ADDENDUM NO: 1

PROJECT: **SITE IMPROVEMENTS AT FRANKLIN CENTRAL JUNIOR HIGH**

CONTEXT PROJECT NO: 22-1613 DATE: 2/13/2024 BY: Fred Prazeau

PRINT DATE: 2/13/24
PLOT SCALE: 1:1 EDIT DATE: 2/13/24 - 12:29 PM EDITED BY: NBALENTINE DRAWING FILE: Z:\PROJECTS\2023\0154 - FRANKLIN CENTRAL JR HIGH\2. DESIGN\CAD\C500 EROSION CONTROL PLAN TENNIS PAVED LOT.DWG

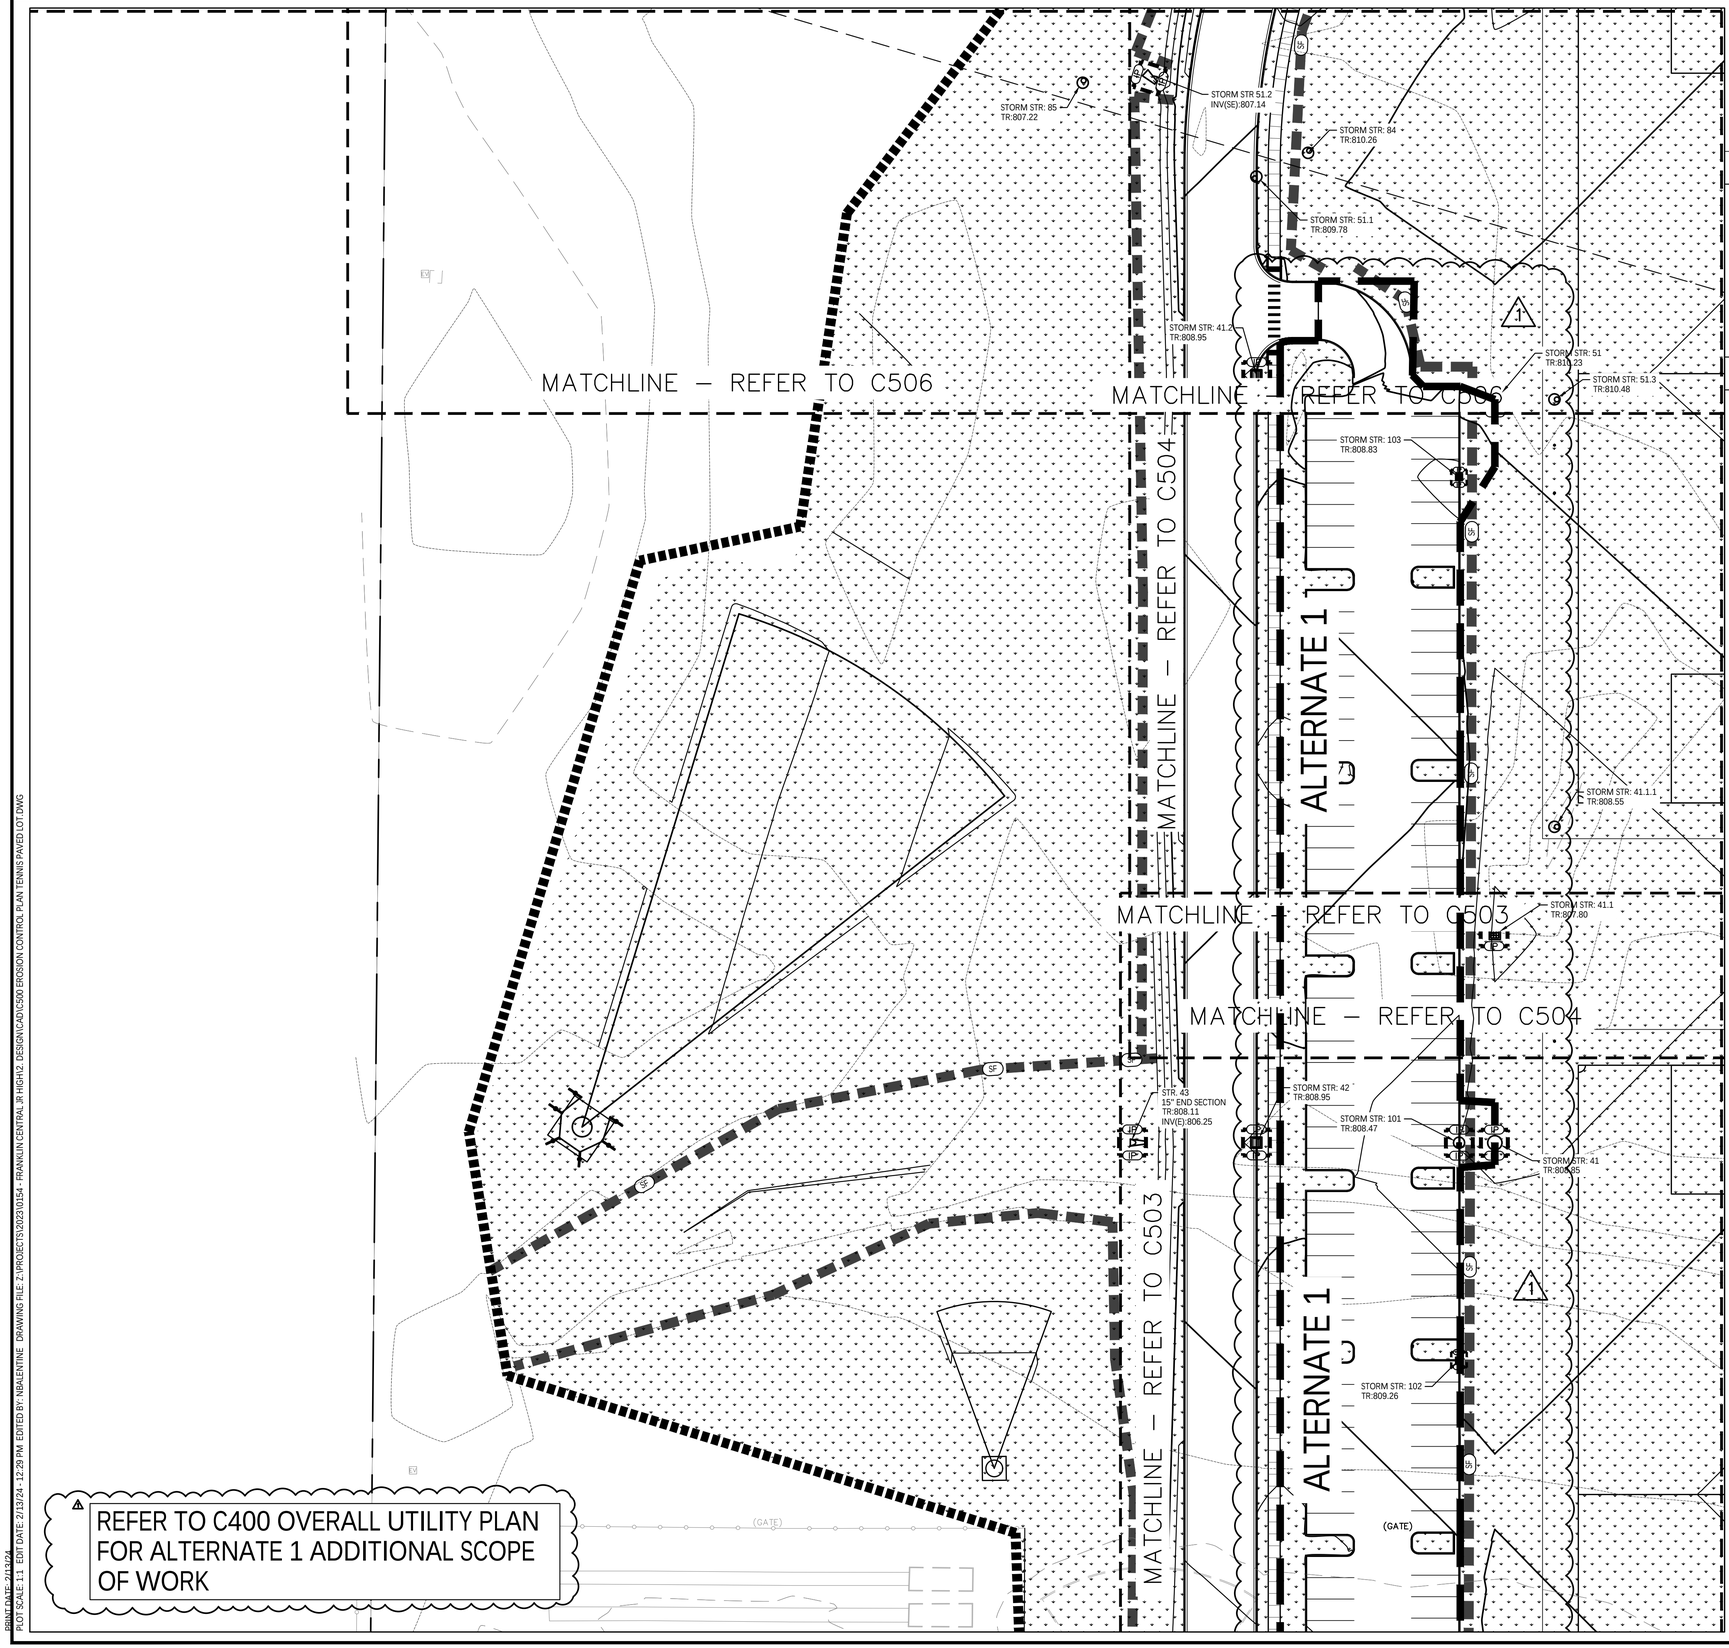
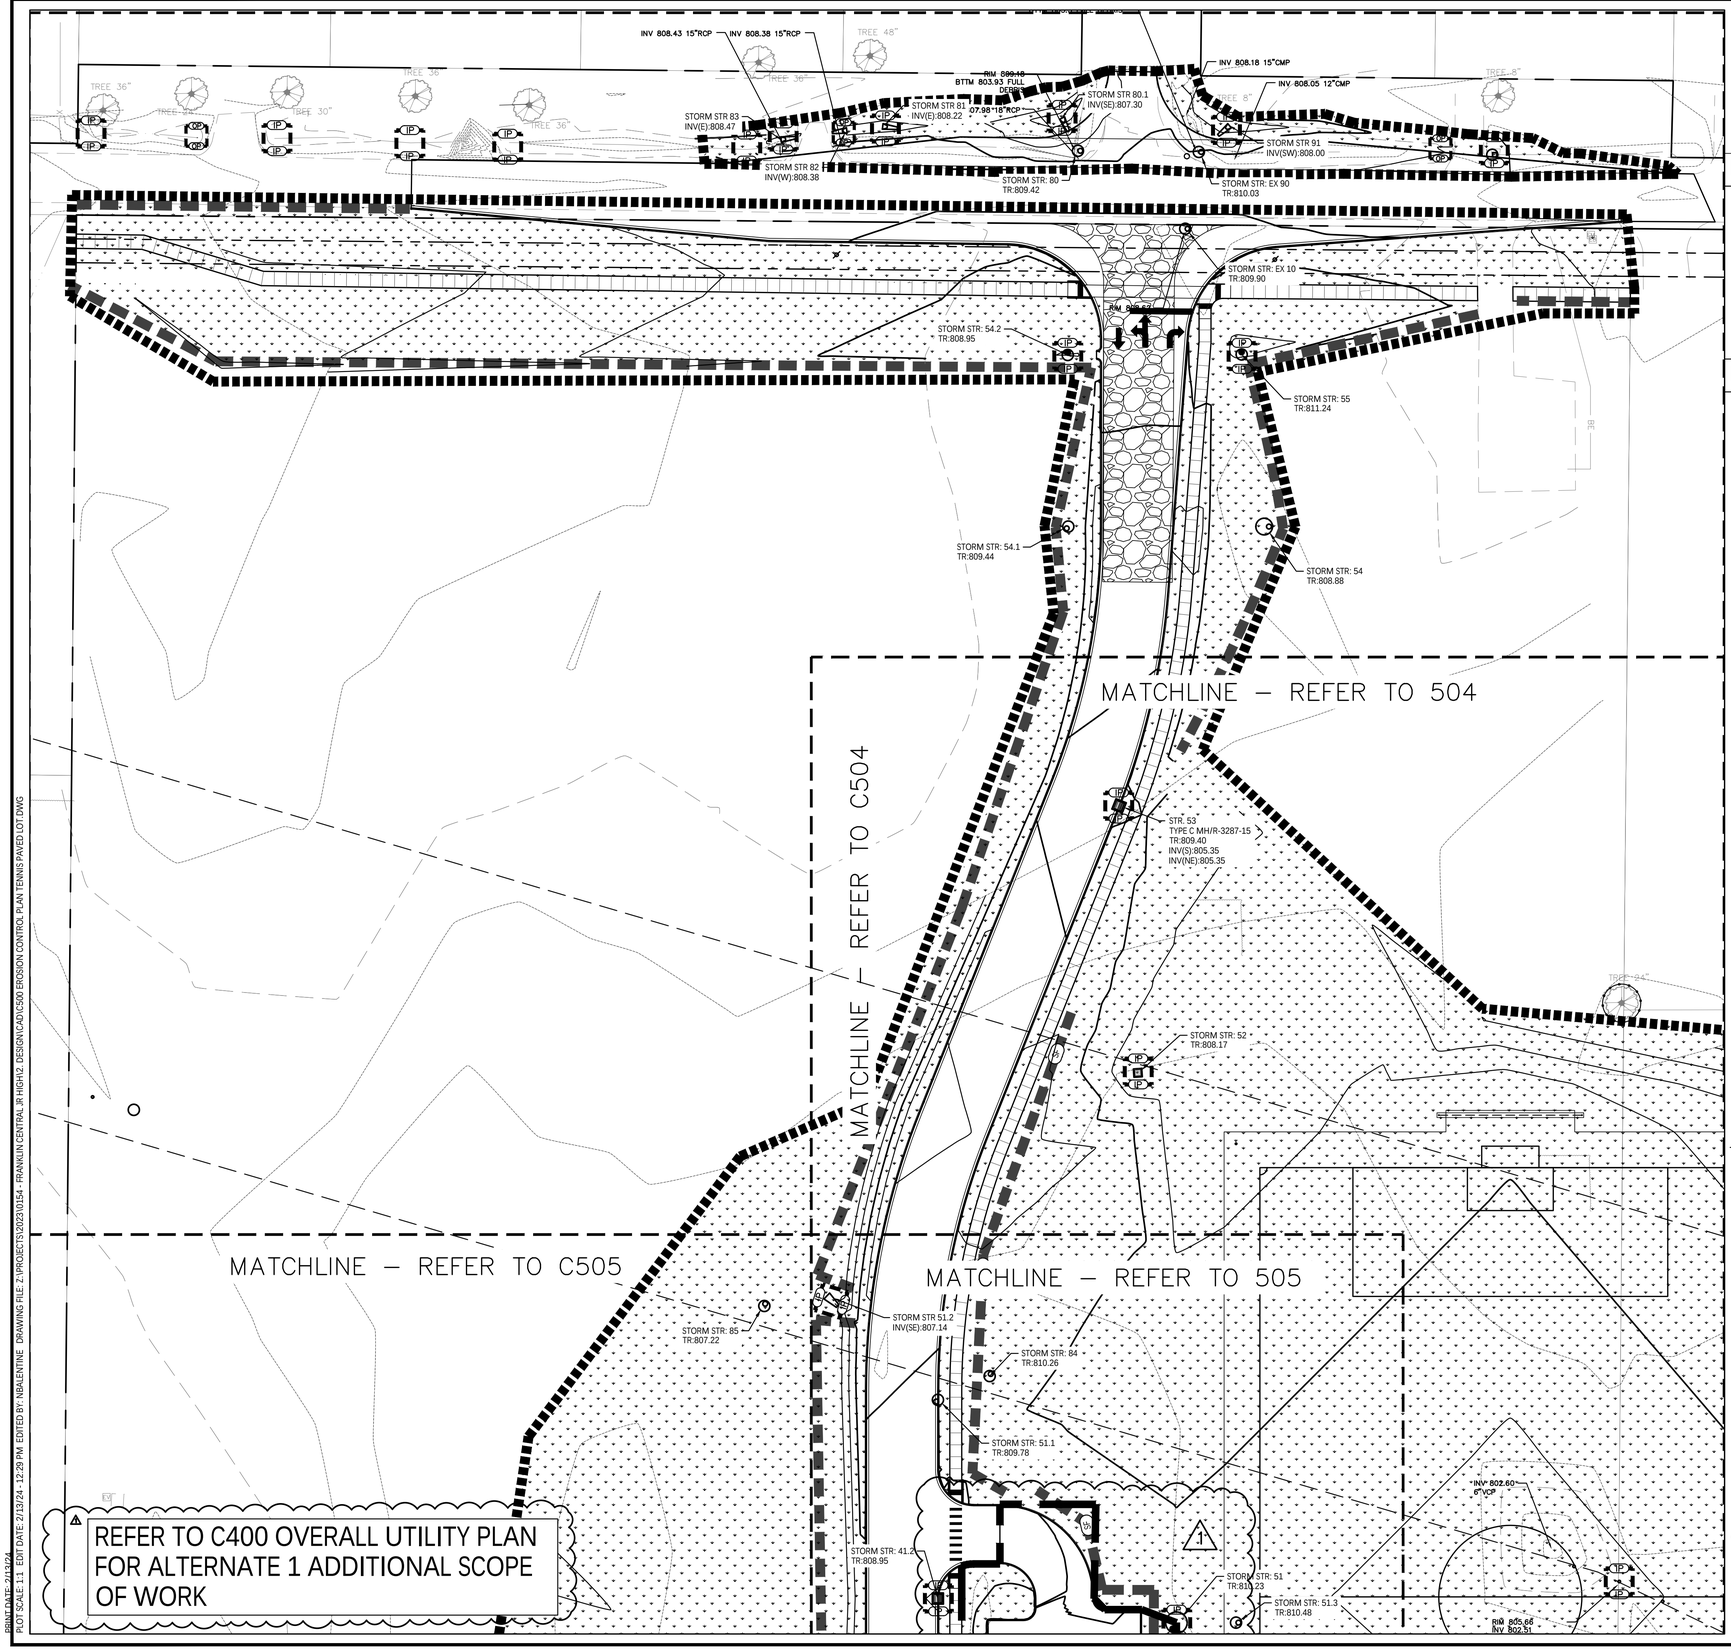
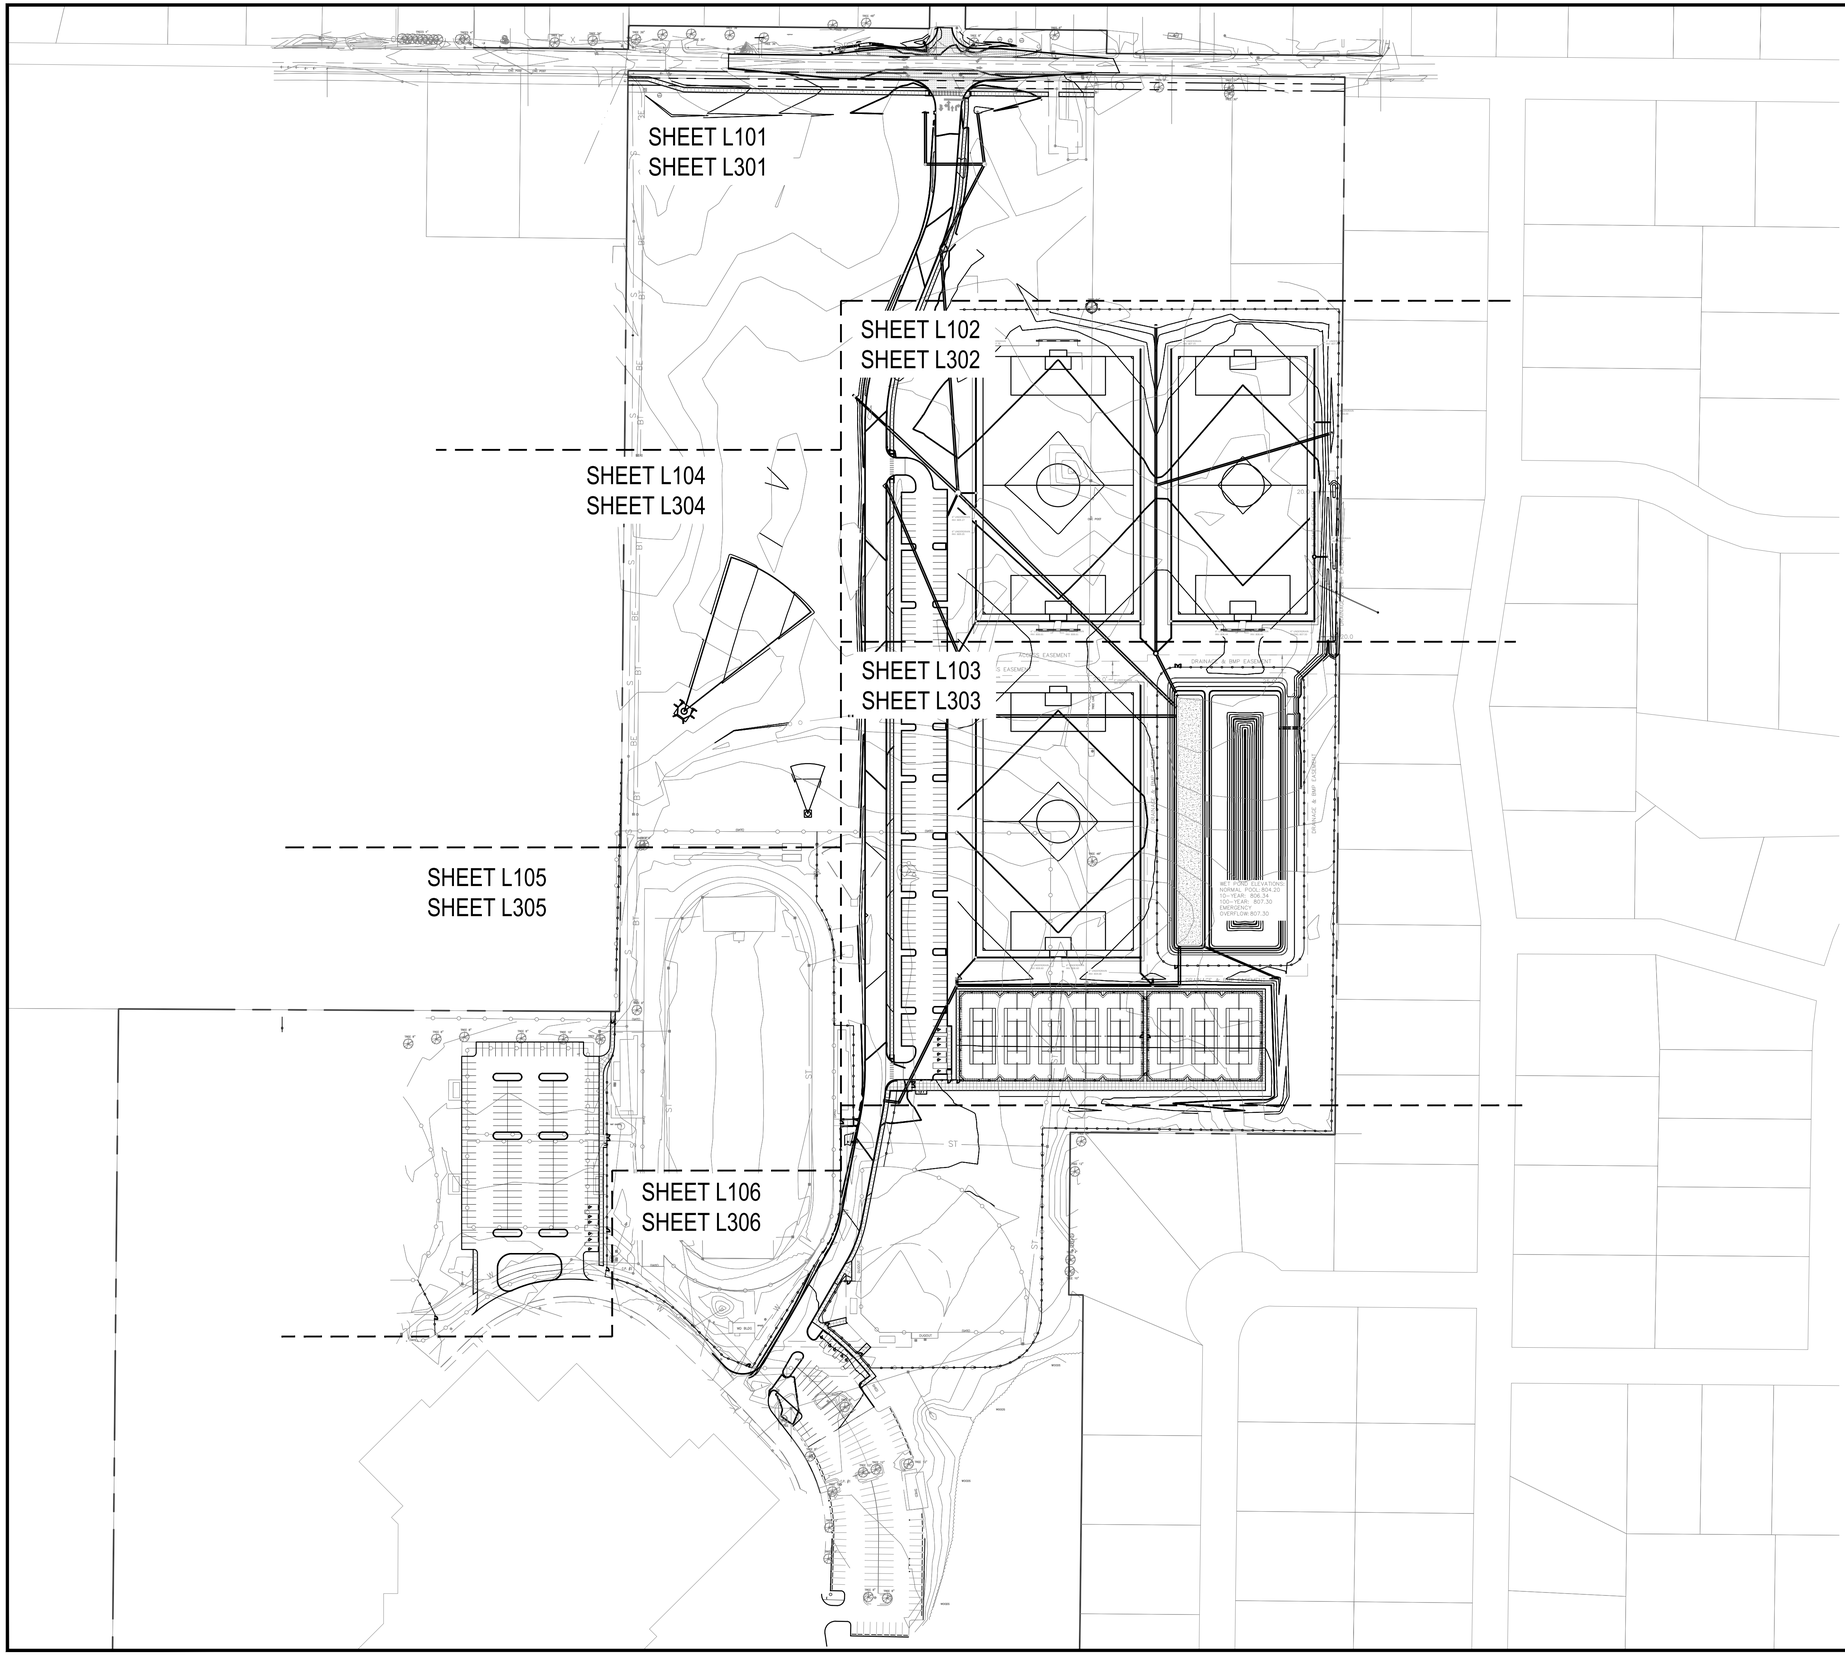
5. C430-Series Regulated Drain Replacement Plans reissued to match Alternates listed on Bid Form.
6. C500-Series Erosion Control Plans reissued to address City comments, including clarification in the vicinity of the Alternate #1 – Soccer Parking lot.
